Delegated Report

Householder Planning Application

Planning Application No: 20230557

Description: Installation of a dropped the kerb for vehicular access to the front of the property.

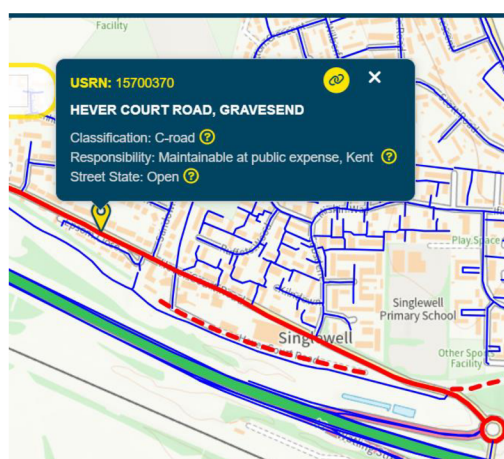
The existing hardstanding measures approx. 5.17m in depth and 3.84m in width. The submission does not include any detailed plans and there is only the below proposed block plan which indicates the size and location of the proposal.

As can be seen from the above image the front garden of the property is used for off road parking and there is no dropped kerb in place. To the west of the property, there is a semi-detached dwelling with a driveway, however this benefits from a wider frontage.

The existing front garden has had the laid to lawn front garden and other soft landscaping removed and replaced with block paving to create off road parking for one vehicle. The existing situation is that a vehicle would have to 'bump' up the existing kerb which over time is likely to cause damage to the kerb and footpath and due to the size of the parking area, a vehicle would not be able to exit the property in a forward gear due to the inability to turn within the parking space.

The width of the front garden is a maximum of 3.8m which is considerably below the acceptable standards. Whilst it is acknowledged that there are other properties that have parking in the front garden area along this stretch of Hever Court Road, there does not appear to be a record of planning permission.
